Reserve at Jewel Lake

COVINGTON

TYPICAL 38' - 1607 - RH UNLESS NOTED OTHERWISE Florida Region (Frame)

REVISIONS

FIRST FLOOR ELECTRICAL PLAN 'A'

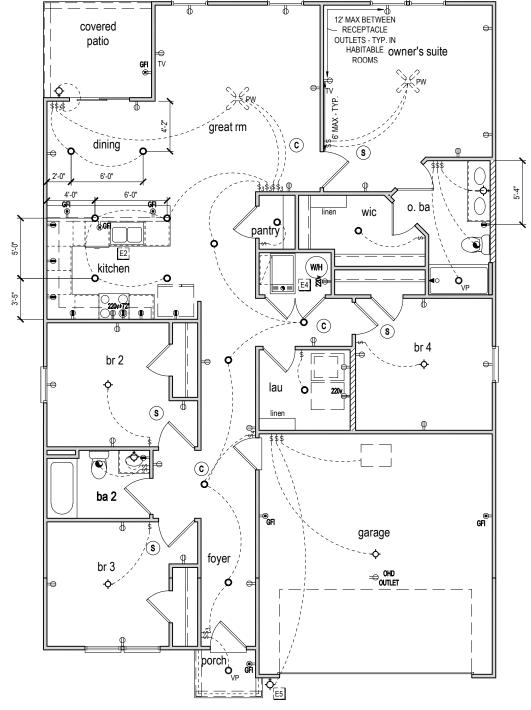
Added outlet to O.Suite & noted outlets to meet 6' max from wall break & 12' max between outlet spacing at habitable rooms (E1.1)
